Safety Evaluation Report

Related to Renewal of the Facility Operating License
for the University of Massachusetts Lowell Research
Reactor

License No. R-125
Docket No. 50-223

U.S. Nuclear Regulatory Commission

Figure 5-16 Loss of Flow Case 1 (Reactor Initially Operating at 1.25 MWt with Inlet Temperature 43.3 °C and Flow Rate 1,700 gpm)

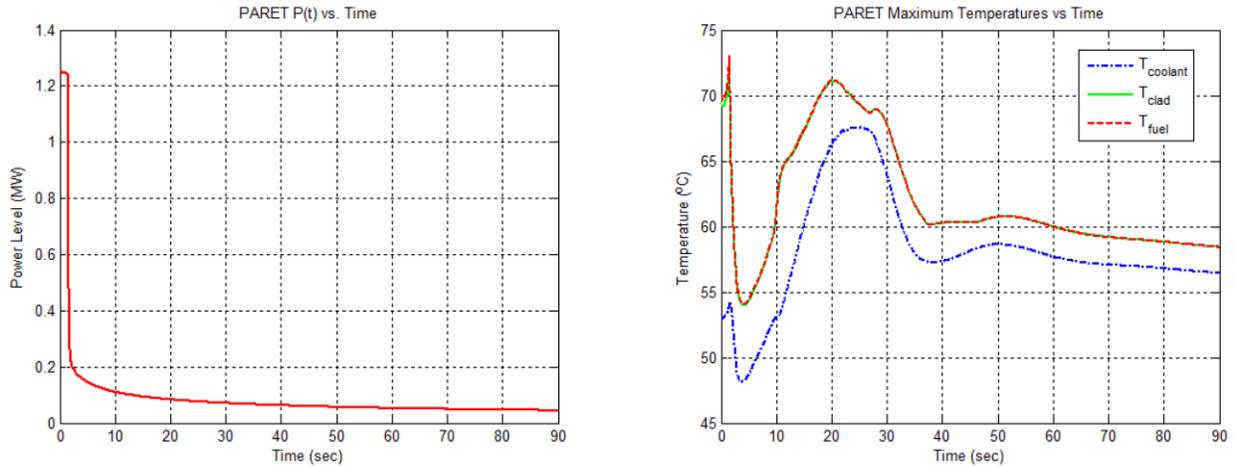
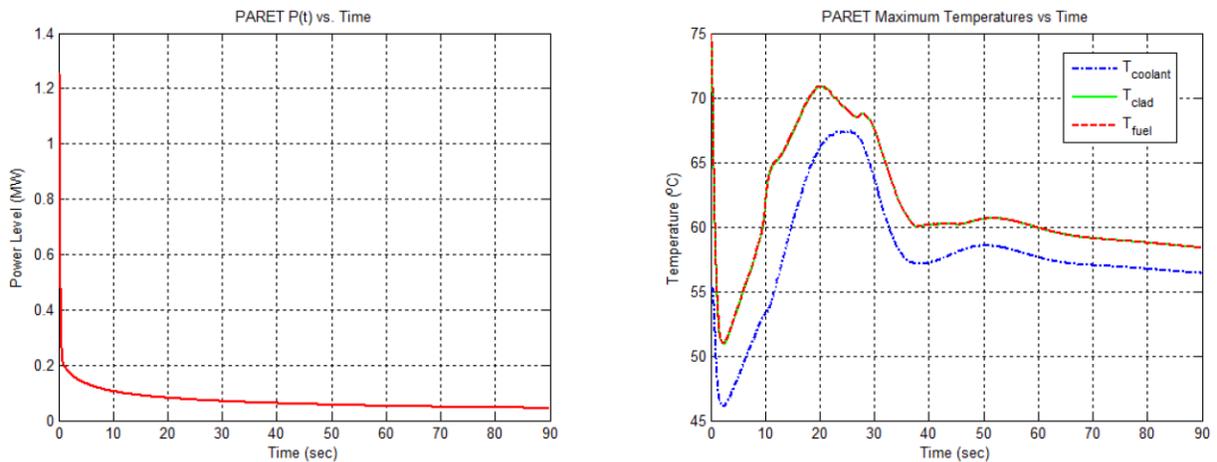
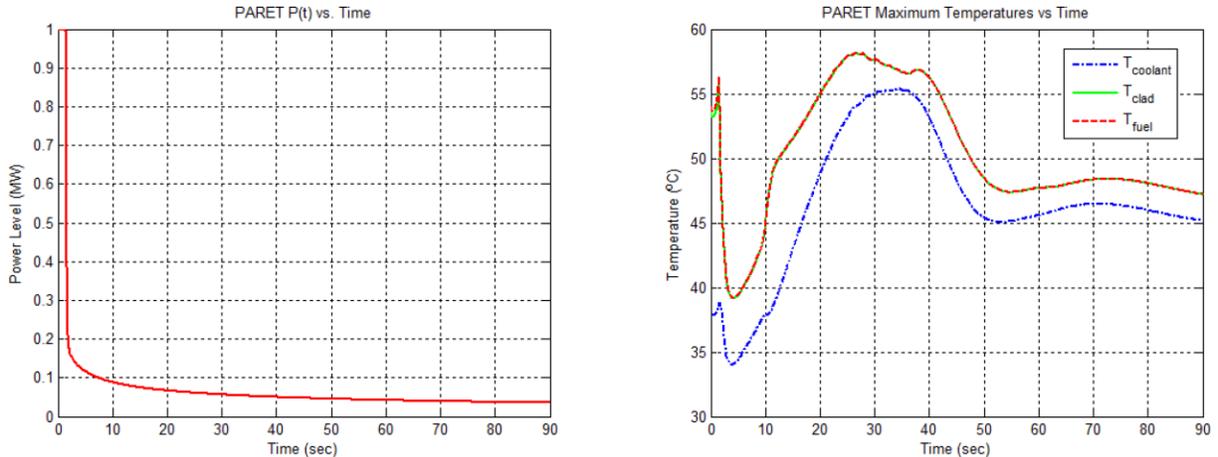
The figures show that the maximum fuel cladding temperature reached is about 75 °C (167 °F) for case 2 immediately prior to the scram, which is well below the SL, ONB, and temperatures at which any fuel failure could occur. UML noted that, for all three cases, the fuel temperatures quickly drop when the reactor scrams (for cases 1 and 3, there is a notable small increase in temperature before the reactor scrams from the decrease in flow rate prior to the scram). The temperature then rises back up as the pump flow rate continues to decrease, but falls again as natural convection flow is established.

The NRC staff calculated a maximum fuel cladding temperature of approximately 57 °C (135 °F), reached approximately 20 seconds after the pump shuts off. This is similar to UML's result for case 3, illustrated in SER Figure 5-18 above, which similarly assumed an initial reactor power of 1.0 MWt. Although the NRC staff's calculation did not consider a worst-case (i.e., LSSS) initial power level, the NRC staff finds that its calculation result illustrates the reasonableness of UML's results, and supports UML's determination that pump-off loss of flow scenarios would not cause the fuel to reach temperatures that could cause damage. The NRC staff also finds that the differences in its result and UML's results are reasonable given the differences in methodologies and assumptions used.

Figure 6-1 UMLRR TS Figure 6-1

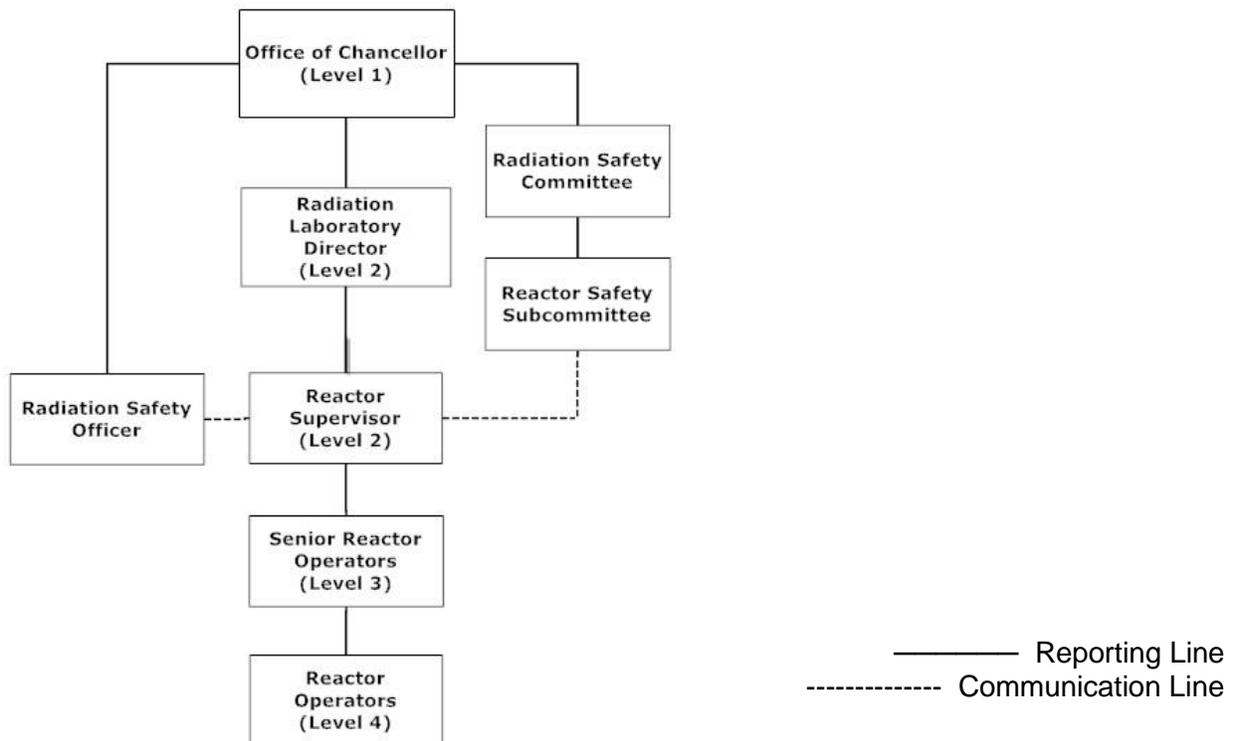
TS 6.1.1 would require that the structure of the UMLRR operating organization be as shown in TS Figure 6-1, which is reproduced below as SER Figure 6-1. As indicated by the TS Figure 6-1 caption, solid lines denote reporting lines, and dashed lines denote communication lines. The NRC staff finds that TS 6.1.1 helps ensure that the UMLRR organizational structure, including the communication and reporting lines, is appropriately defined and properly delineated in the TSs. The NRC staff finds that UML’s designation of two individuals as Level 2 authorities is appropriate, because both individuals have management authority over UMLRR operation, and because TS 6.1.1 (in conjunction with TS 6.1.2) clearly designates which Level 2 has the higher authority. The NRC staff also finds that by delineating the UMLRR organizational structure, TS 6.1.1 appropriately implements the guidance in NUREG-1537, Appendix 14.1, and ANSI/ANS-15.1-2007. Therefore, based on the above and based on its 10 CFR 50.36(c)(5) findings for TSs on administrative controls in SER Section 6.7, the NRC staff concludes that TS 6.1.1, including TS Figure 6-1, is acceptable.

TS 6.1.2 would require that the Level 1 authority indicated in TS Figure 6-1 be an individual at a position of associate vice chancellor or higher, who has overall responsibility for the UMLRR license, and is responsible for ensuring that UMLRR activities are in accordance with NRC regulations. TS 6.1.2 would also require that the Reactor Supervisor (lower Level 2 authority indicated in TS Figure 6-1) report to, and have direct responsibility to, the Director of the Radiation Laboratory (upper Level 2 authority indicated in TS Figure 6-1) for the safety of UMLRR activities and compliance with the UMLRR TSs; per TS Figure 6-1, the Director of the Radiation Laboratory in turn reports to the Level 1. TS 6.1.2 would additionally require that the UML campus radiation safety officer (RSO) (see SER Section 4.1.2) be responsible for radiation protection at the UMLRR, advise the Reactor Supervisor on all matters related to radiation protection, and report to and be directly responsible to the Level 1 in matters pertaining to radiation safety. The NRC staff finds that TS 6.1.2 helps ensure that the responsibilities of key positions in the UMLRR organizational structure, including responsibilities for compliance with the UMLRR license and NRC regulations, are clearly delineated. The NRC staff finds that TS 6.1.2, in conjunction with TS 6.1.1, helps ensure that the Level 1 authority is an upper-level UML official who has ultimate responsibility for the UMLRR license and who can make UML resources available as needed to ensure facility safety. Regarding TS 6.1.2, and other TSs in Section 6.0, "Administrative Controls," the NRC staff notes that it does not consider any personnel responsibilities, review requirements, procedure requirements, etc., delineated in the TSs to imply applicability for any purpose other than ensuring nuclear and radiological safety and that NRC requirements are met, with respect to activities conducted under NRC Facility Operating License No. R-125 for the UMLRR. The NRC staff also finds that by clearly defining the responsibilities to UML personnel as they relate to the UMLRR, TS 6.1.2 appropriately implements the guidance in NUREG-1537, Appendix 14.1, and ANSI/ANS-15.1-2007. Therefore, based on the above and based on its 10 CFR 50.36(c)(5) findings for TSs on administrative controls in SER Section 6.7, the NRC staff concludes that TS 6.1.2 is acceptable.
